MFD NON-COMPLIANCE REPORT # 30121-1

PART NAME: **HXU PROTO INTERSPACE PL**
PF/SA NO.: **SA-389-893-00 R1**
WORK ORDER NO.: **30121-1 (8924593)**
VENDOR **MFD**

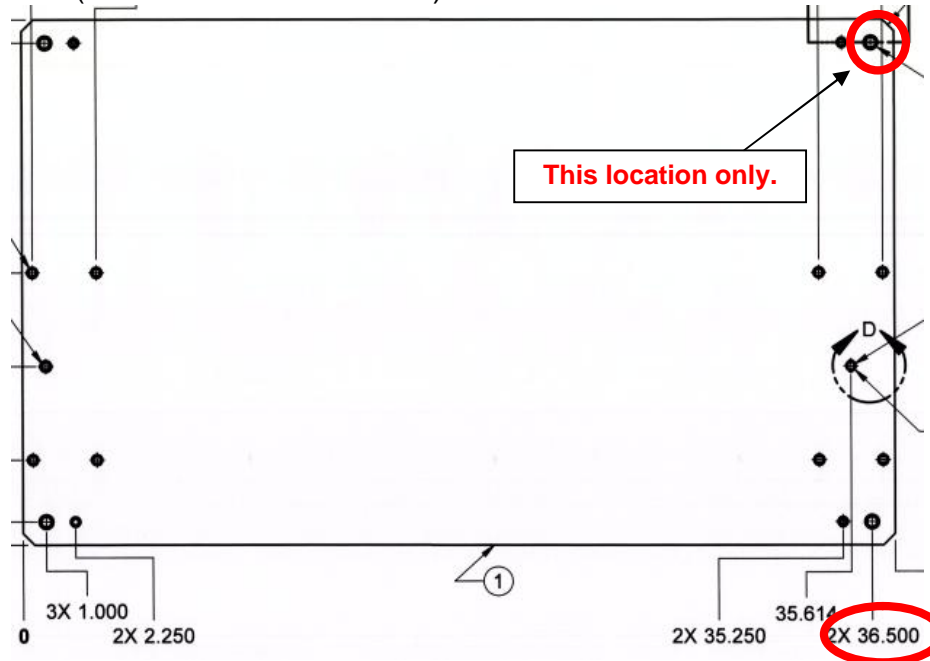
1. Distance of Helicoil $\frac{1}{2}$ -13 (STI Thread) 2X 36.500 \pm 0.005" is out of tolerance on 1 of 2 holes measuring 36.4906 (-0.0044" out of tolerance). See below for location and for clarity.

2. With respect to the Waterjet cut, holes near end of length drifted X = -0.009", Y = -0.008".
